RESOLUTION HOLDING HEARING ON REQUEST FROM KUM & GO, LC FOR AMENDMENT TO THE KUM & GO STORE #120 PUD CONCEPTUAL PLAN ON PROPERTY LOCATED AT 6304 SOUTHWEST 9TH STREET

Communication from the City Plan and Zoning Commission advising that at their meeting held August 6, 2015, the following action was taken regarding a request from Kum & Go, LC (owner) represented by Nick Halfhill (officer) for amendment to the Kum & Go Store #120 PUD Conceptual Plan on property located at 6304 Southwest 9th Street.

APPROVAL of a the proposed Conceptual Plan amendment to allow an approved 6,321-square foot convenience store with 16 fueling locations to have a reconfigured site layout and a revised store and canopy design to fit the current corporate prototype subject to the following conditions: (ZON2015-00128)

**KUM & GO STORE #120 PUD (2ND AMENDMENT)
 A PLANNED UNIT DEVELOPMENT IN THE CITY OF
 DES MOINES, COUNTY OF POLK, STATE OF IOWA
 6304 SW 9TH STREET
 DES MOINES, IA**

STORE #120 - DES MOINES, IA
 6304 SW 9TH STREET
 BUILDING EXTERIOR ELEVATIONS

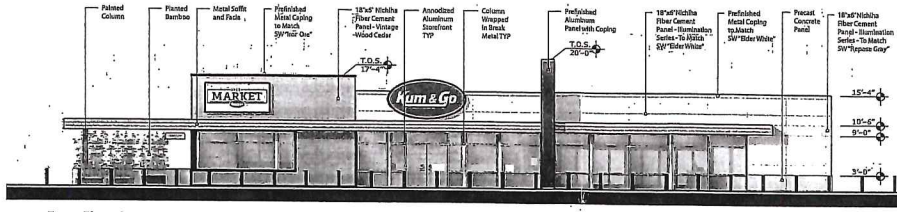
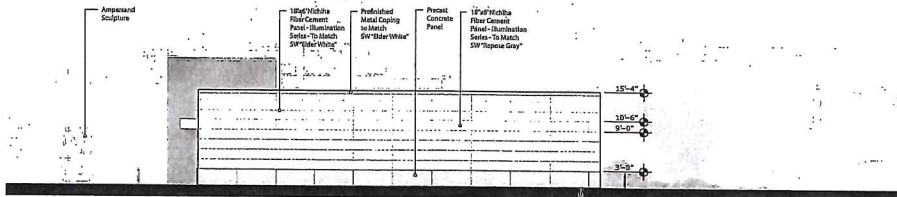
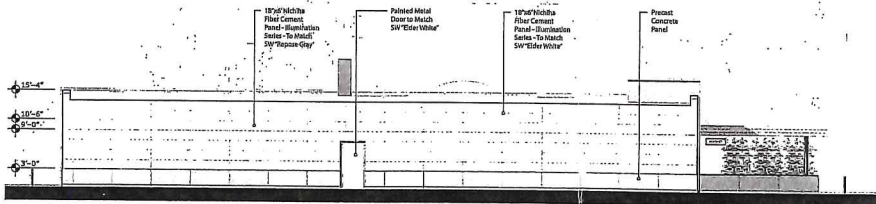
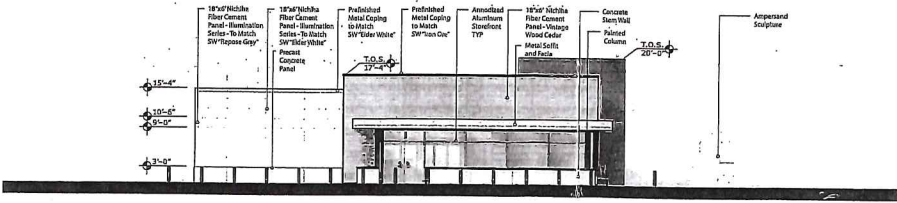
The proposed building and trash enclosure would consist of a precast concrete base with Nichiha Fiber Cement Panel siding on the upper portions. A metal sided feature is proposed on the front façade of the building. Staff believes the proposed trash enclosure walls should be constructed of precast concrete or masonry and steel gates to ensure the enclosure's long term durability and appearance.

The proposed canopy would be sided with a metal material and supported by columns wrapped in metal cladding. Staff believes the columns should be wrapped in a masonry or precast concrete product.

The primary canopy structure would not exceed 18 feet in height including signage. The revised design includes two ornamental elements consisting of Nichiha Fiber Cement Panels that would sit on top of the canopy. The height of the canopy as measured at the Nichiha element would be 21'-6". Staff believes that the proposed height is appropriate given that the primary canopy structure does not exceed 18 feet and that the taller portion consists of an ornamental element that provides visual interest to the canopy.

1. All pump island canopy columns shall be wrapped with a masonry or other similar product as approved by the Planning Administrator.

2. Any dumpster enclosure shall be constructed with masonry or precast concrete walls and steel gates as approved by the Planning Administrator.
3. Any monument sign shall have a maximum height of 8 feet.
4. Any monument sign shall have a solid opaque base constructed of brick, stone, concrete block or other durable material that is no less than 2 feet in height as approved by the Planning Administrator. The base shall extend from grade to the bottom of the sign face across the entire width of the sign face.
